# **CITY OF ST. PETERSBURG, FLORIDA** PLANNING AND DEVELOPMENT SERVICES DEPARTMENT URBAN PLANNING AND HISTORIC PRESERVATION DIVISION

# Community Planning and Preservation Commission Ad Valorem Tax Exemption Request

Case No.:	AVT 21-90400002
Request:	Review of an Ad Valorem Tax Exemption request for an addition to, and rehabilitation of, the property at 458 Joyce Terrace North, a contributing property to the Round Lake National Register Historic District.
Legal Description:	CASHWELL'S 2 <sup>ND</sup> SUB LOT 28
Parcel ID No.:	18-31-17-14202-000-0280
Date of Construction:	c.1918
Landmark:	Round Lake National Register Historic District
Owners:	Maria Herrera Turner and Thomas L. Turner

Figure 1: Proposed elevations of rehabilitated duplex with rear addition. Red line denotes separation between the original structure and the new addition.

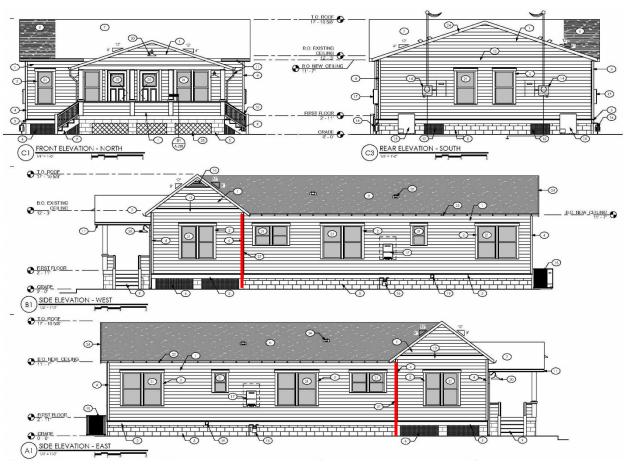
The proposed addition will be one-story with a simple, rectangular form. Both side elevations will be identical, utilizing paired windows that are similar in size to the original structure with traditional spacing. Staff considers the proposed fenestrations in the addition to be part of an appropriate rehabilitation project at this property.

- 1. All features to be restored will match existing.
- 2. Windows and doors shall be recessed in the wall plane to create a 2-to-3-inch reveal to reference historic openings.

Figure 2: Proposed Site Plan

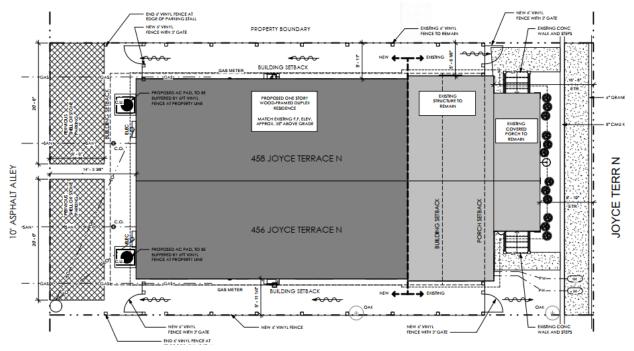
The project also will add approximately 1500 SF to the 500 SF historic duplex. The applicant will be removing the rear additions and detached garage structure. These additions were constructed over the 20<sup>th</sup> century, and the rear additions do not have the proper ceiling height required by Florida Building Code. The garage is not original to the property and was constructed at a later date.
